Engineering Review

EPC Planning & Community
Development Department

**FINAL DRAINAGE REPORT
FOR
STERLING RANCH FILING 3**

**December 2021
Project No. 25188.02
SF-2132**

STERLING RANCH FILING 3 WATER QUALITY DRAINAGE MAP

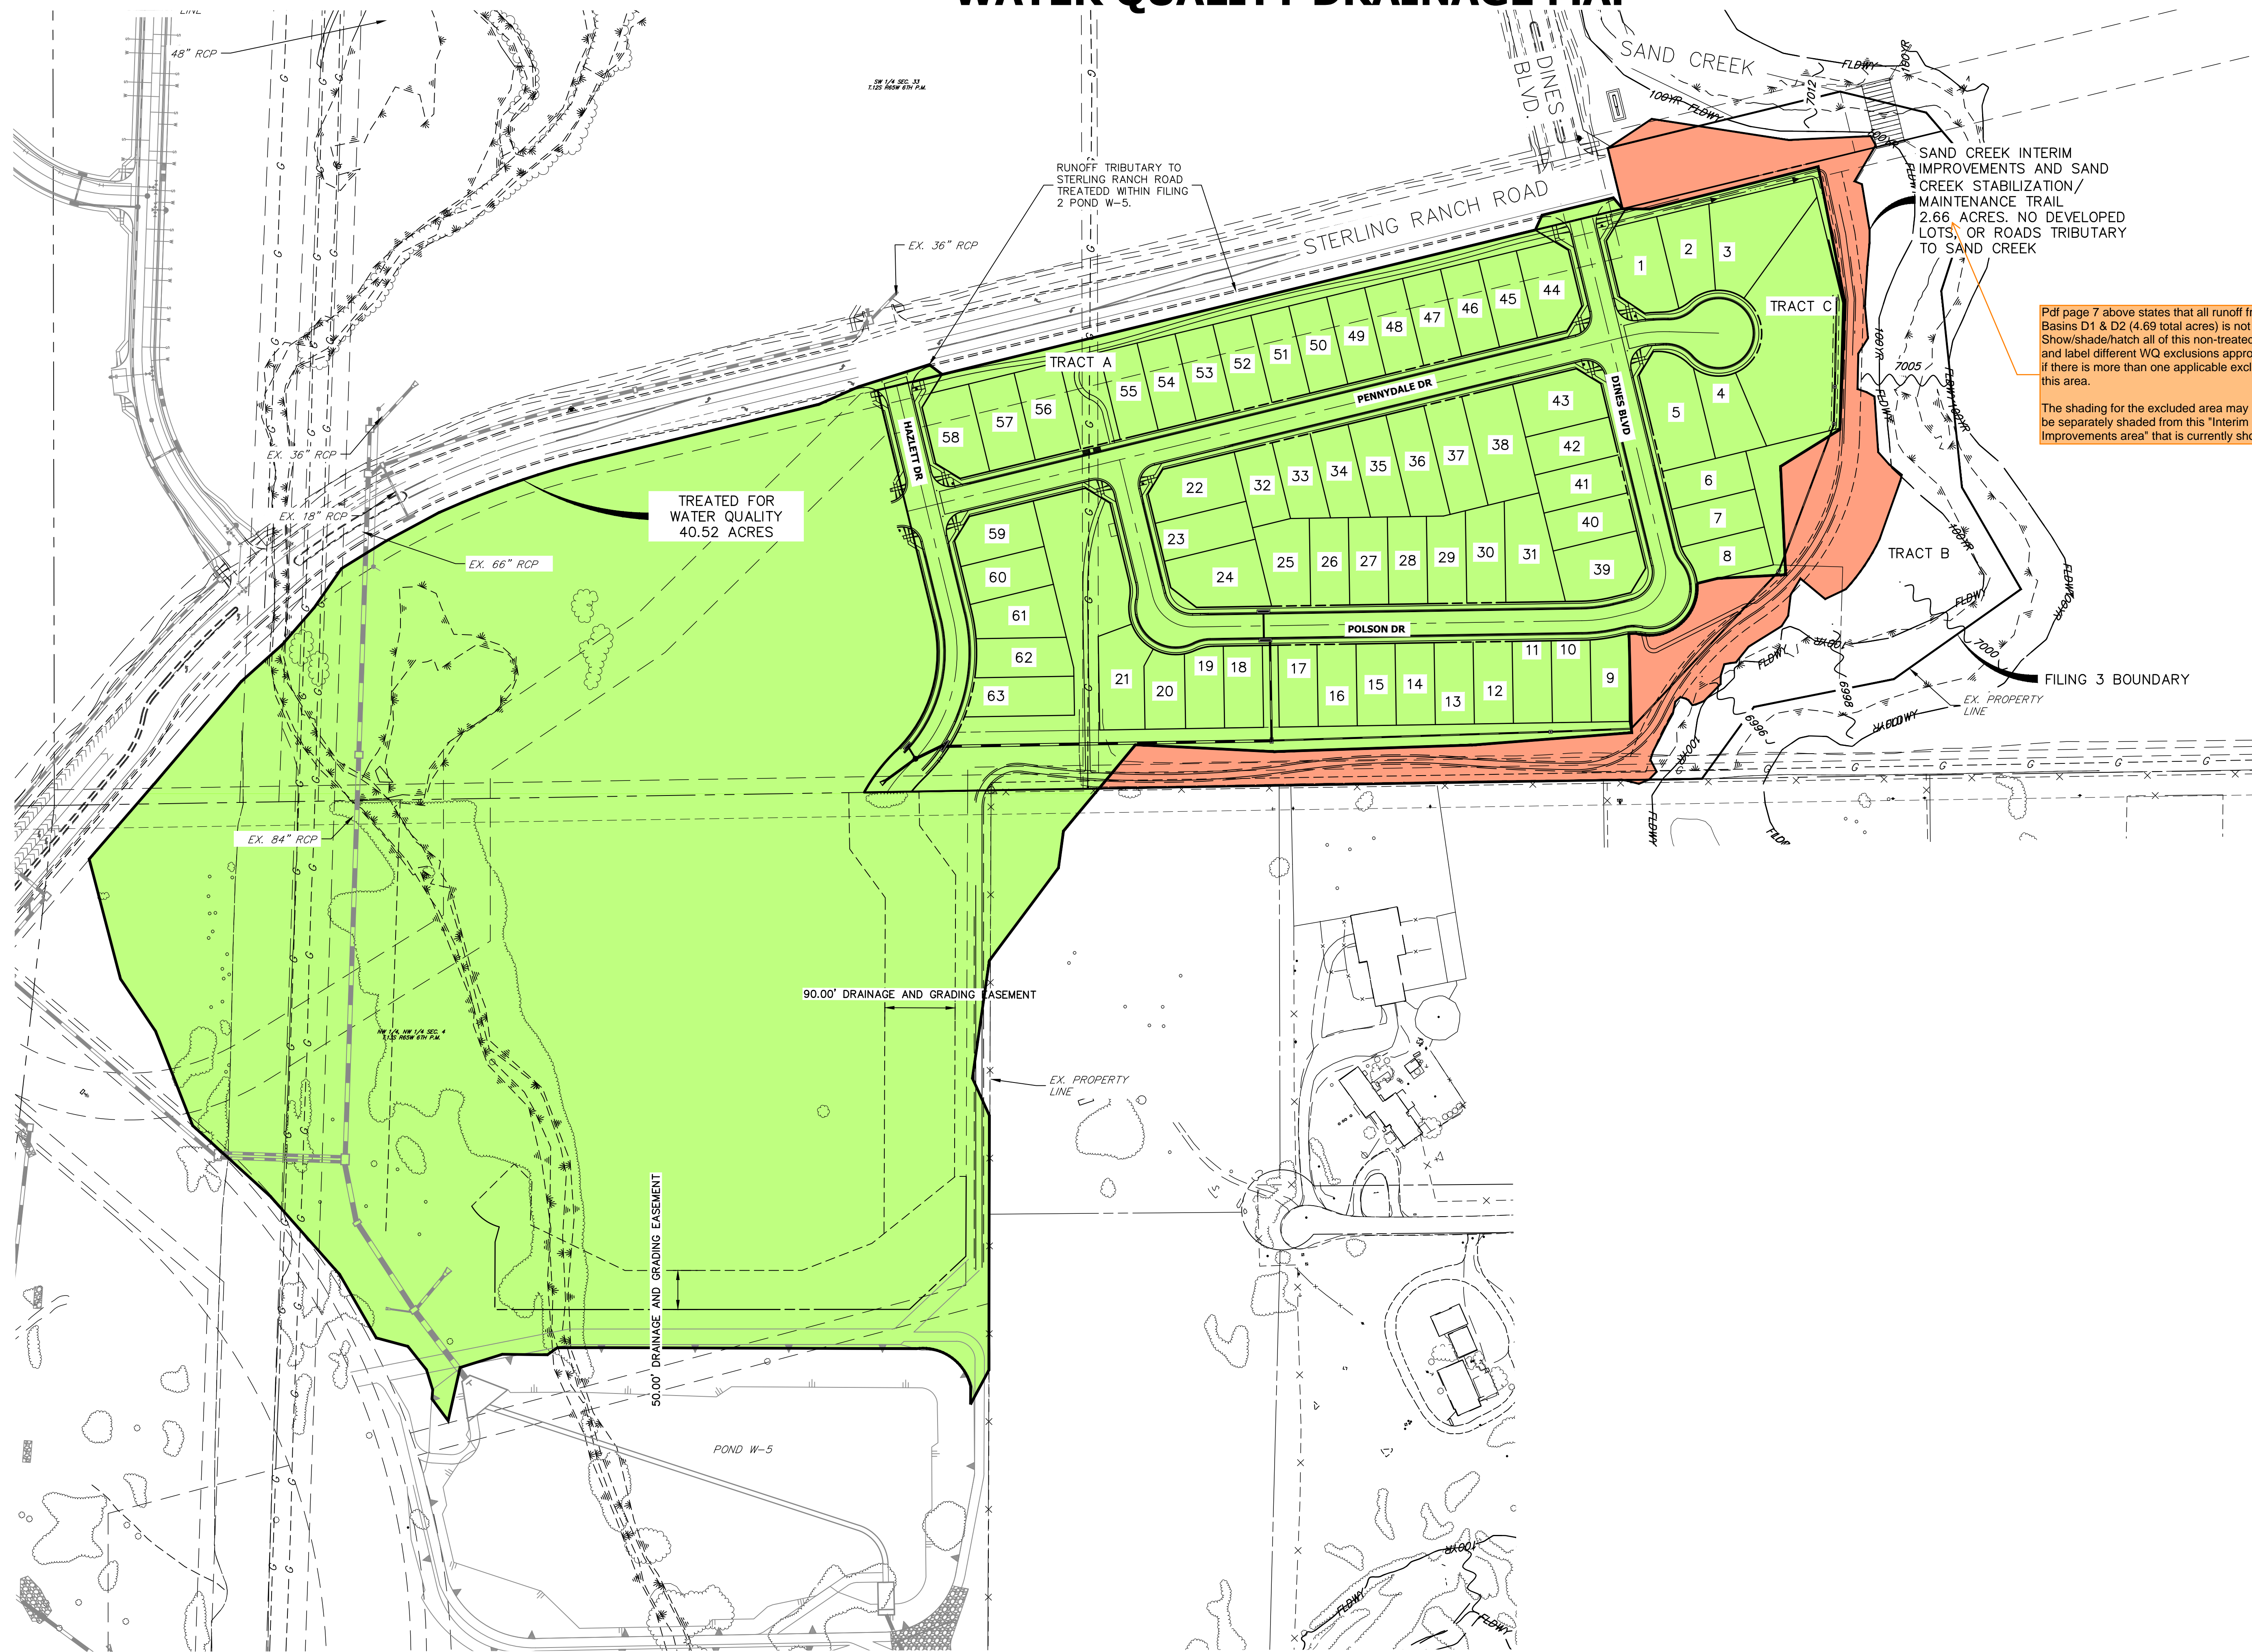
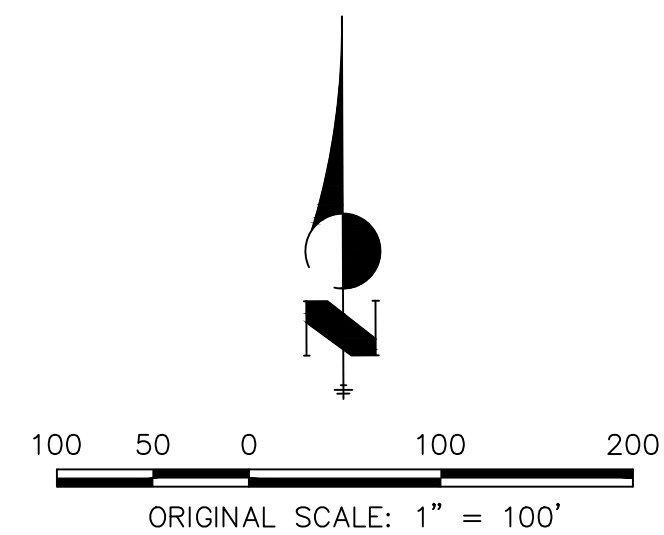
Pdf page 7 above states that all runoff from Basins D1 & D2 (4.69 total acres) is not treated. Show/shade/hatch all of this non-treated area and label different WQ exclusions appropriately if there is more than one applicable exclusion to this area.

The shading for the excluded area may need to be separately shaded from this "Interim Improvements area" that is currently shown.
